**ENGINEERING SAFETY REVIEW SERVICES
SEISMIC SAFETY EXPERT MISSION**

**FOLLOW-UP IAEA MISSION IN
RELATION TO THE FINDINGS AND
LESSONS LEARNED FROM THE
16 JULY 2007 EARTHQUAKE AT
KASHIWAZAKI-KARIWA NPP**

**REPORT TO
THE GOVERNMENT OF JAPAN**

Facility: Kashiwazaki-Kariwa NPP, Units 1 – 7

Finding Title: A2-07 –INTEGRITY ASSESSMENT OF SYSTEMS AND COMPONENTS

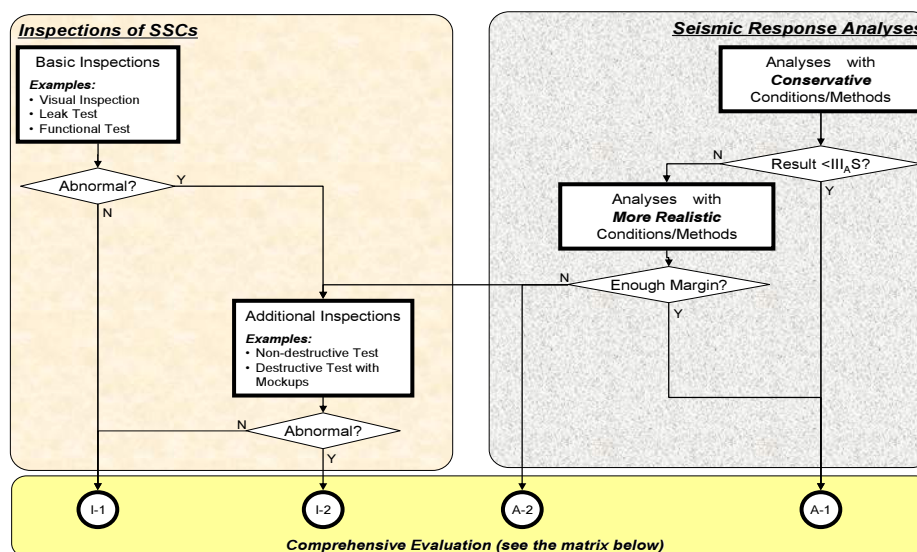
- During discussions with NISA and TEPCO, it was understood that the integrity assessment plan developed by TEPCO uses both analysis and inspection to assess the integrity of SSCs. The use of both inspection and analysis to assess the integrity of components leads to separating the components into four basic categories as shown above.

1. While discussing the analytical portion of the integrity evaluation plan developed by TEPCO, it was noted that the simple models used by TEPCO in its analysis –following the same criteria adopted at the time of the original design- may not always provide answers or explanations to the effects observed as consequence of the earthquake and may not always provide conservative results. This topic was discussed with the Japanese counterparts who agreed with the observation.

2. It was noted that some of the analyses presented by TEPCO used a set of assumptions, criteria and methods that may need to be reviewed, should the plant be re-evaluated to a higher seismic input. It was suggested to TEPCO that it would be better to adopt a more realistic set of assumptions, methods, modelling and acceptance criteria for these analyses, in order to proceed consistently during the entire re-evaluation process.
